Office Action Summary	Application No. 10/764,071	Applicant(s) KEJEJIAN, TOROS	
	Examiner David C. Reese	Art Unit 3677

DETAILED ACTION

a pavilion (see figure below);

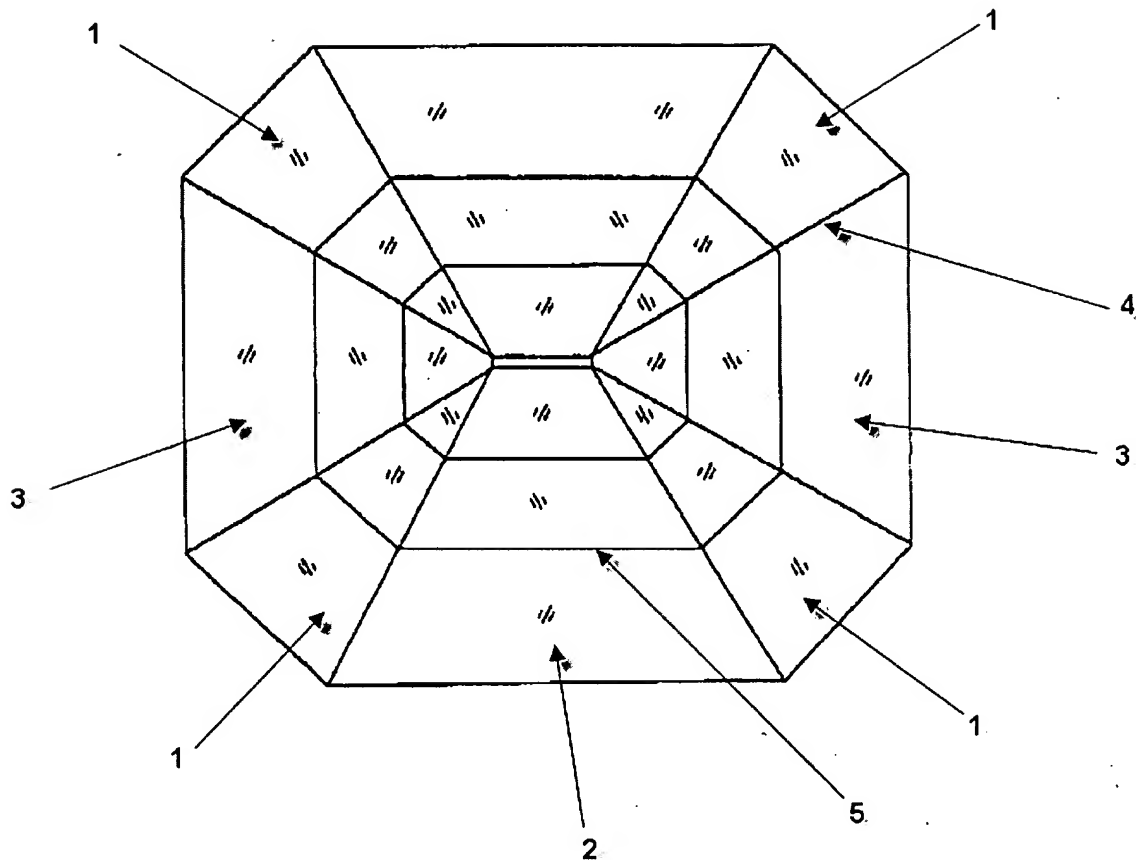
[4] Claim 21 is rejected under 35 U.S.C. 102(e(1)) as being unpatentable over Abaev, US-D499, 981, because the invention was patented or described in a printed publication in this or a foreign country, or in public use or on sale in this country more than one (1) year prior to the application for patent in the United States.

The shape and appearance of Abaev is identical in all material respects to that of the claimed design, *Hupp v. Siroflec of America Inc.*, 122 F.3d 1456, 43 USPQ2d 1887 (Fed. Cir. 1997).

As for Claim 1, Abaev teaches of a mixed cut gemstone comprising:

four lower corner facets (1), said lower corner facets being triangles (1);

two long-side lower girdle facets (2), said long-side lower girdle facets being triangles or trapezoids (2);

two short-side lower girdle facets (3), said short-side lower girdle facets being triangles (3);

a plurality of step cuts (5), said step cuts being substantially equal in width; and

a plurality of rib lines (4);

whereby said steps cuts (5) are cut at a predetermined angle with respect to said lower girdle facets (2,3) with each step (5) being at a slightly different angle, said different angle step cuts (5) [allowing light that passes through the crown to hit the plurality of steps cuts at different angles thereby bending the light several times in different directions thus providing the gemstone with parallel incoming and outgoing rays of light that make the gemstone appear more brilliant and scintillated].
